Re: BZA Application No.16559
The Field School
2301 Foxhall Road, N.W.

MEMORANDUM

SUBJECT: Revised Field School Transportation Plan

Figure 1
Foxhall Road Southbound
Left Turn Lane Improvement

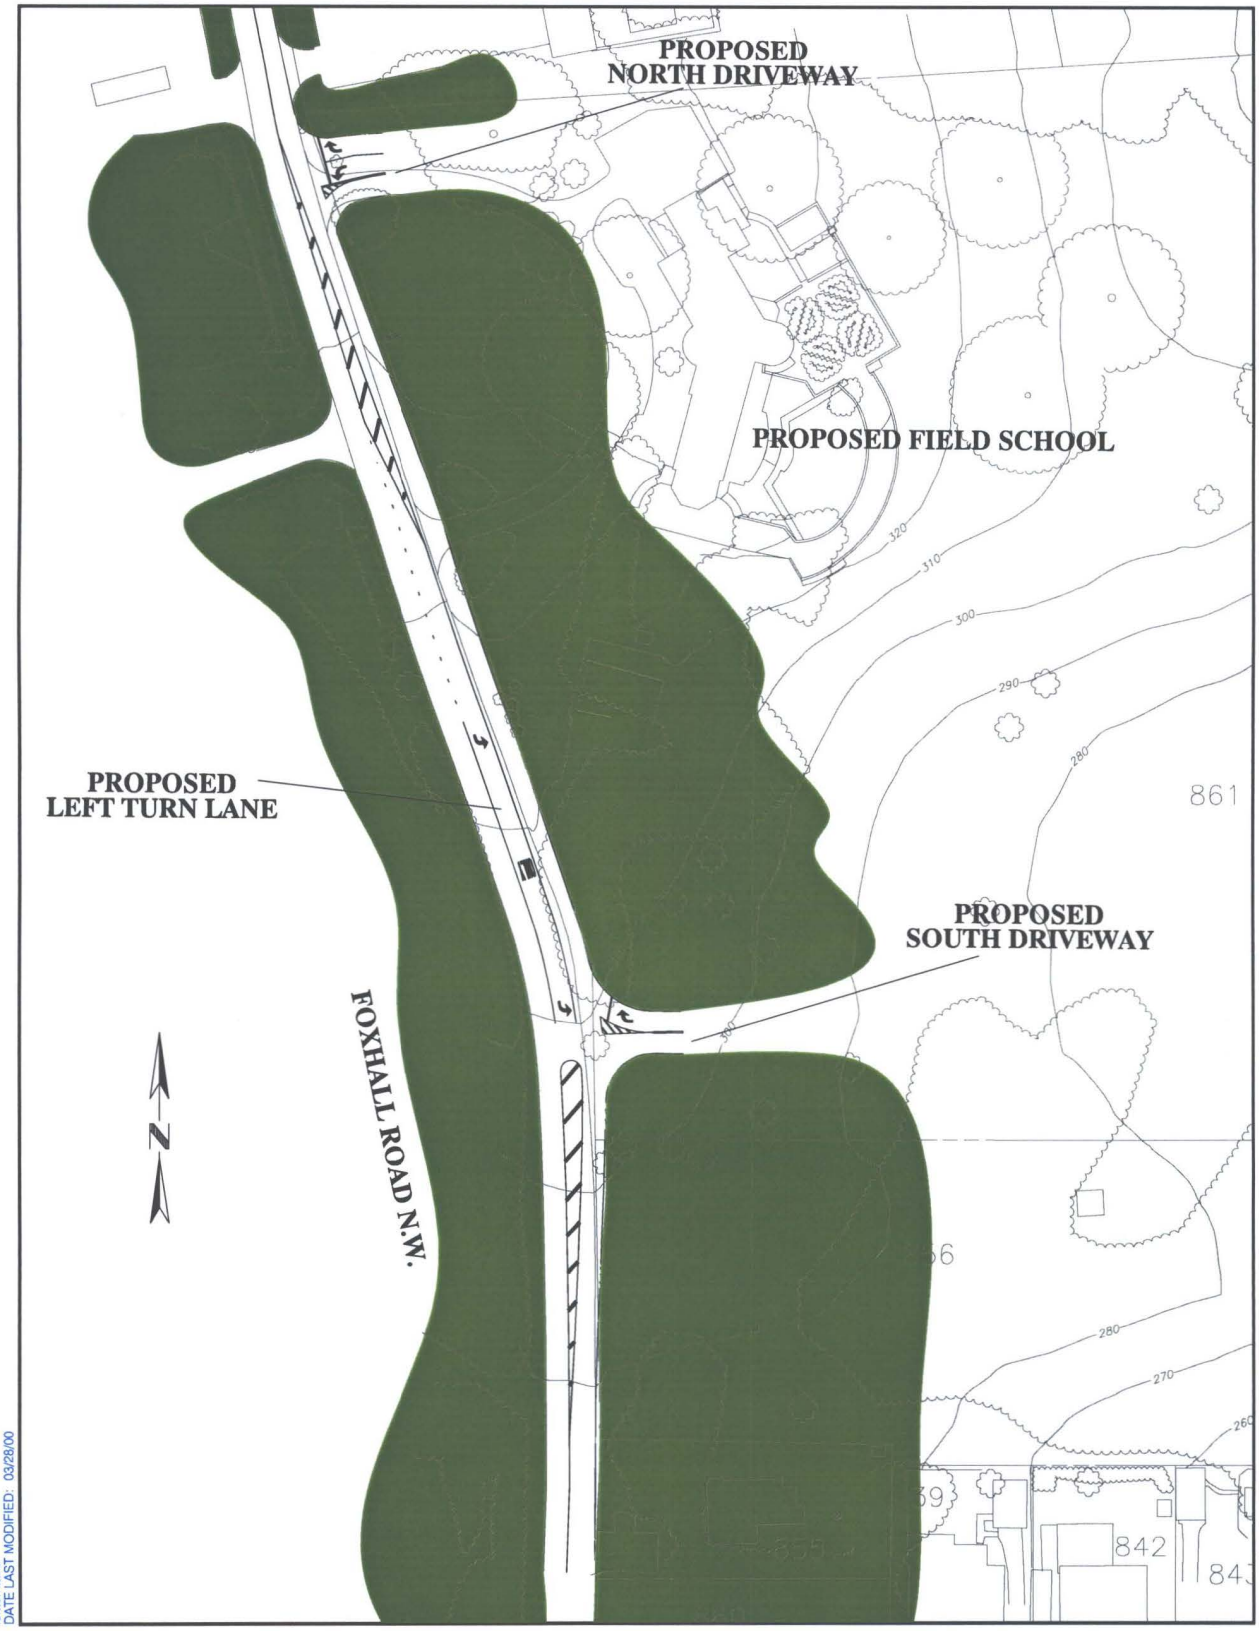
Figure 1 presents the revised transportation plan for The Field School with the proposed southbound, dedicated left-turn lane in the Foxhall Road right-of-way.

- In response to a recommendation made by DCDPW, a southbound left-turn lane on Foxhall Road in front of The Field School property has been designed to accommodate southbound left-turns into the site at a modified southern entrance. The Foxhall Road widening to accommodate this lane has been accomplished by utilizing the existing right-of-way on the east side of Foxhall Road in front of The Field School property.

- The dedicated southbound left-turn lane will have the ability to store approximately 10 passenger cars waiting to turn left into the site. With the proposed traffic signal at the intersection of Foxhall Road and Whitehaven Parkway, gaps within the northbound traffic stream will be created to allow for safe passage of left-turning vehicles into The Field School property. Further, the School still proposes to utilize a police officer in the morning to ensure safety. The road widening accommodates an "island" where the officer can stand. Based on an analysis accounting for the projected conditions along Foxhall Road, the proposed southbound left-turn lane will be adequate to serve the left turns into the Field School.

- The previously located southern entrance, which was restricted to right turns in and right turns out, along Foxhall Road has been shifted 120 feet to the north to a location approximately 200 feet north of the southern property line. This change allows for better access into the site with the new left-turn lane and creates a greater separation between the southern property line and the newly relocated southern entrance.

- With the addition of the southbound left-turn lane, inbound vehicles destined for The Field School will be allowed to turn left into the site without impeding through traffic along Foxhall Road.
